Re: Preliminary Planning Report, Revision 1
Ellsworth Industrial Park Site

Weston Solutions, Inc. (WESTON) is pleased to submit for U.S. EPA's review, two copies of Revision 1 to the Preliminary Planning Report (PPR) for the Ellsworth Industrial Park Site in Downers Grove, Illinois. This revision incorporates changes to the PPR that were based on comments received from the Ellsworth Industrial Park Respondents ("Ellsworth Group"). The comments received from the Ellsworth Group include comment letters submitted by the following parties:

The content of this letter and the attached replacement pages, when used in combination with the original information contained in Revision 0 of the PPR constitute the final version of the PPR, which is submitted for your approval. This approach, using replacement pages and the explanations provided within this letter was selected as the preferred method of responding to the comments and finalizing the PPR in the most timely manner possible. Therefore, this letter and the attached replacement pages in combination with the PPR, Revision 0 (WESTON, 2006) will fulfill the requirement for the Conceptual Site Model (CSM), data gap evaluation, project pl

WORK ORDER NO.:	PROJECT MANAGER:
DRAWN BY: NJK	CHECKED BY:
DRAWING NAME:	DIRECTORY FOLDER: Ellsworth_Industrial_Park_OU1_20_06_01.dwg
CONTRACT NO.:	DELIVERY ORDER NO.:
SCALE:	REPORT DATE:
DATE: March 2006	REVISION NO.:
	FIGURE NO. C-2

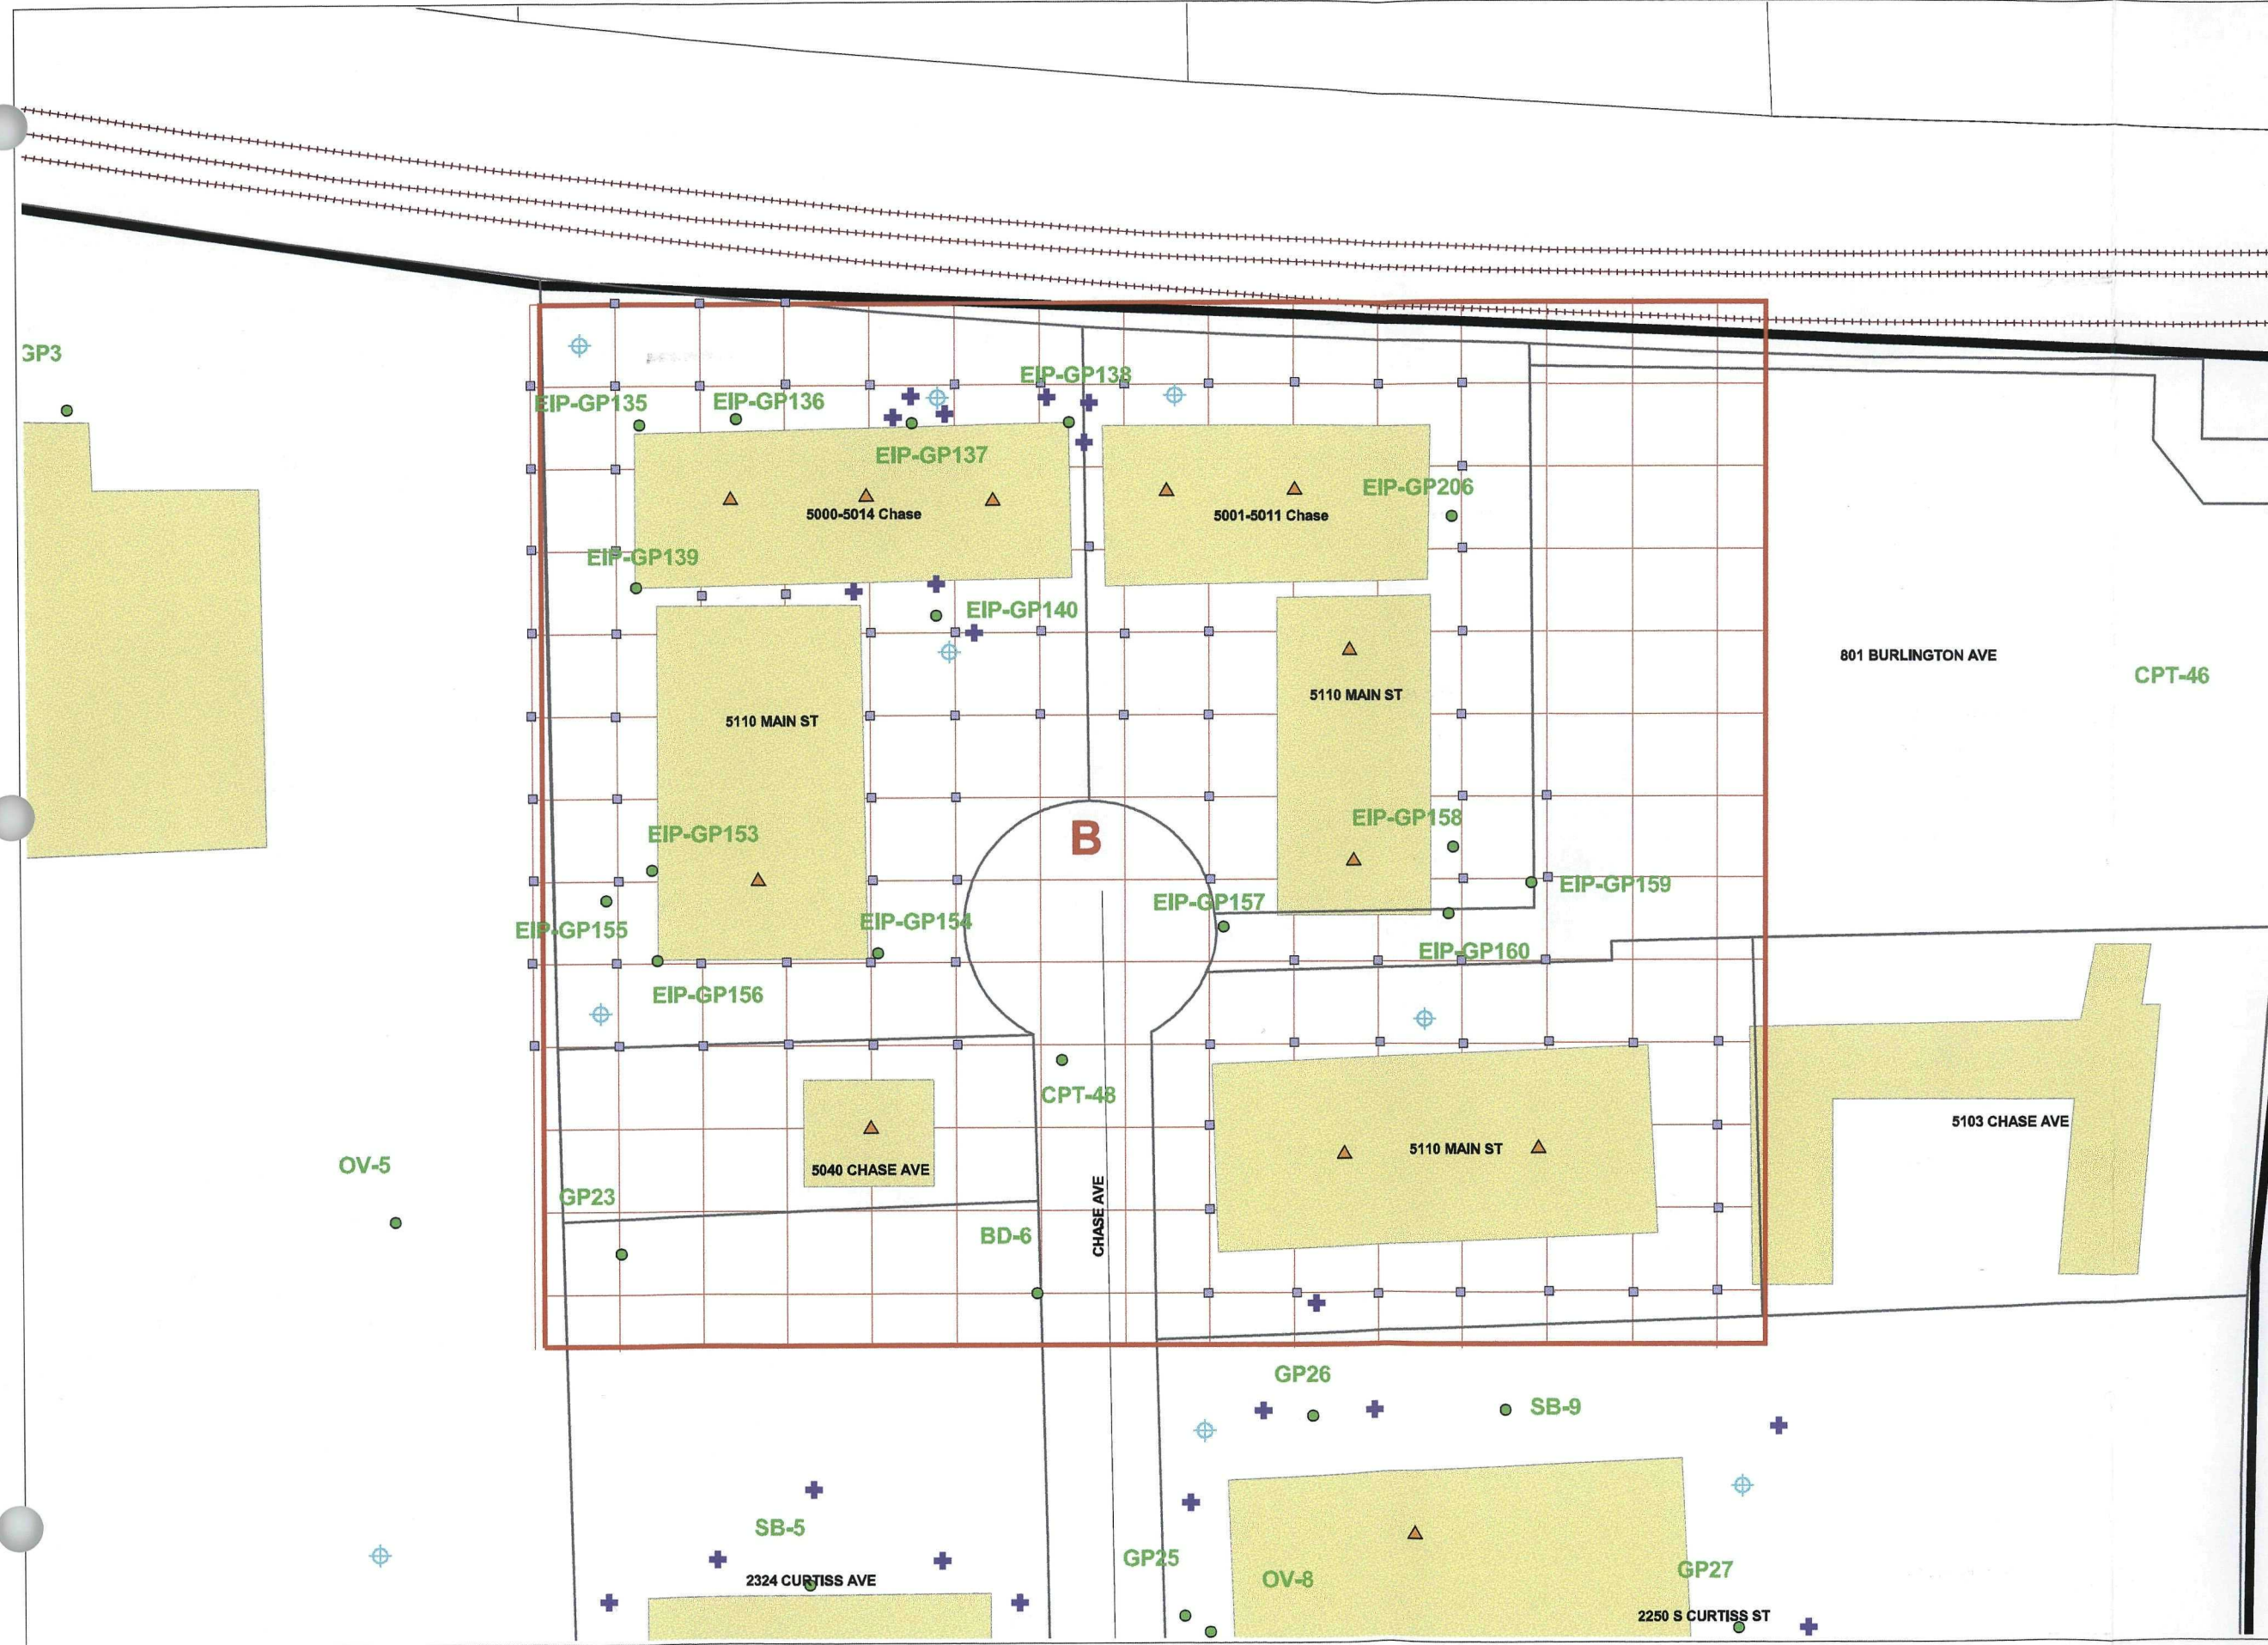
A total of 24 soil borings are proposed for Study Area B, however, 15 of them are not illustrated on Figure C-2, because the locations will be determined based on the results of the utility corridor survey, sub-slab sampling, soil gas sampling, and analytical results presented in the PPR. For costing purposes, it is assumed that a total of 19 soil borings will be advanced to depths ranging from 20 to 40 ft bgs. If the existing analytical data, utility corridor survey, sub-slab sampling, and the soil gas sampling do not discover any chlorinated solvent contamination within this study area, the number of soil borings advanced may be decreased, potentially excluding some of the 24 soil borings proposed for Study Area B. The number of soil borings, the placement of these borings, and the soil sampling depths will be determined based on the evolving CSM, and the quantities and/or locations indicated above and in Table C-1 and Figure C-2 are preliminary.

The proposed locations of the intermediate monitoring wells within Study Area B are illustrated on Figure C-2. The exact locations and number of monitoring wells within Study Area B will be determined based on the evolving CSM, the results of the previous phases of investigation, and field observations. Currently, six intermediate wells are proposed for Study Area B, however, some of these wells could ultimately be classified as shallow or intermediate wells, subject to where groundwater is located. It is assumed that shallow groundwater samples within this area will be

collected during the soil investigation as grab samples. The locations specified on Figure C-2 were based on existing data presented in the PPR, but are subject to revision during the field investigation. For example, if either shallow or intermediate groundwater is encountered in the areas of the proposed locations during the soil investigation, the wells will be relocated prior to installation. Also, based on the results of the soil investigation (both chemical and presence or lack of groundwater), the locations of the wells and also the proposed number may be modified.

WORK ORDER NO.:	PROJECT MANAGER:
DRAWN BY: NJK	CHECKED BY:
DRAWING NAME:	DIRECTORY/ FOLDER: c:\Users\j\Documents\101_20_06_jaw_dwp
CONTRACT NO.:	DELIVERY ORDER NO.:
SCALE:	REPORT DATE:
DATE: March 2006	REVISION NO.:
	FIGURE NO.: C-9

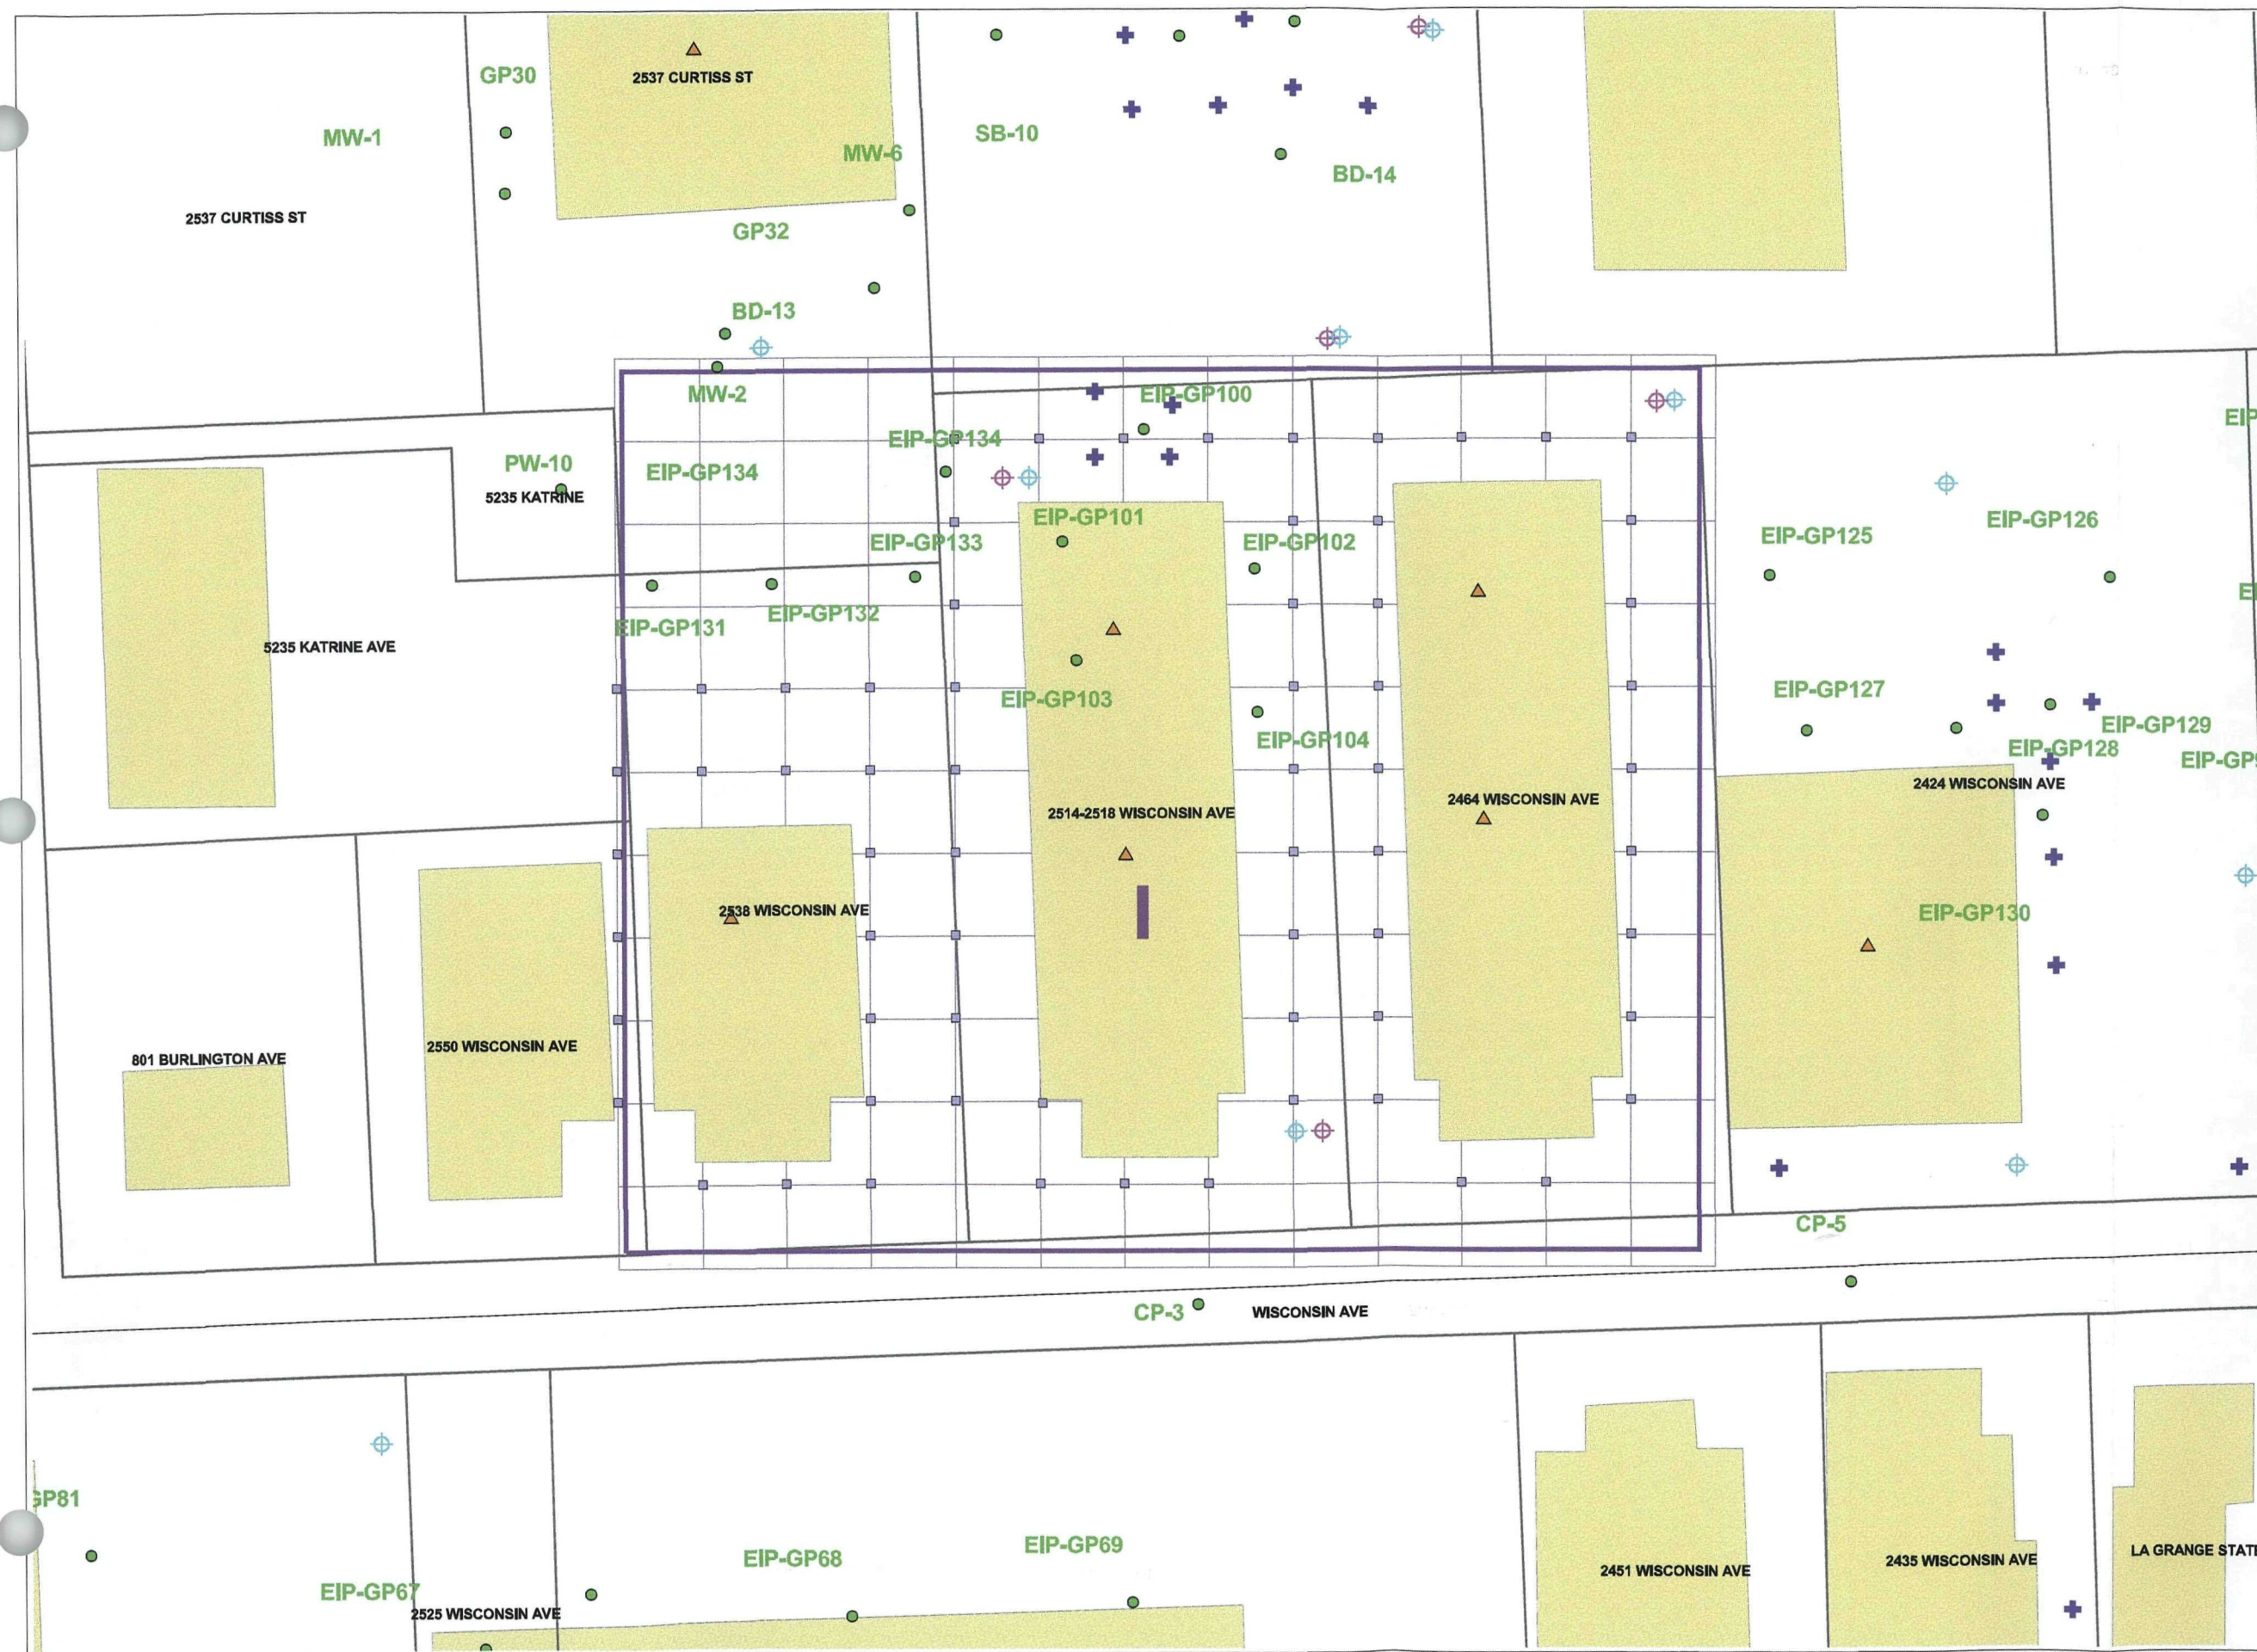
A total of 14 soil borings are proposed for Study Area I, however, 10 of them are not illustrated on Figure C-9, because the locations will be determined based on the results of the utility corridor survey, sub-slab sampling, soil gas sampling, and analytical results presented in the PPR. For costing purposes, it is assumed that a total of 14 soil borings will be advanced to depths ranging from 20 to 40 ft bgs. If the existing analytical data, utility corridor survey, sub-slab sampling, and the soil gas sampling do not discover any chlorinated solvent contamination within this study area, the number of soil borings advanced may be decreased, potentially excluding some of the 14 soil

borings proposed for Study Area I. The number of soil borings, the placement of these borings, and the soil sampling depths will be determined based on the evolving CSM, and the quantities and/or locations indicated above and in Table C-1 and Figure C-9 are preliminary.

The proposed locations of the shallow and intermediate monitoring wells within Study Area I are illustrated on Figure C-9. The exact locations and number of monitoring wells within Study Area I will be determined based on the evolving CSM, the results of the previous phases of investigation, and field observations. Currently, three shallow and three intermediate wells are proposed for Study Area I, however, this distribution between shallow and intermediate is subject to where groundwater is detected. It is assumed that additional shallow groundwater samples within this area will be collected during the soil investigation as grab samples. The locations specified on Figure C-9 were based on existing data presented in the PPR, but are subject to revision during the field investigation. For example, if either shallow or intermediate groundwater is not encountered in the areas of the proposed locations during the soil investigation, the wells will be relocated prior to installation. Also, based on the results of the soil investigation (both chemical and presence or lack of groundwater), the locations of the wells and also the proposed number may be modified.
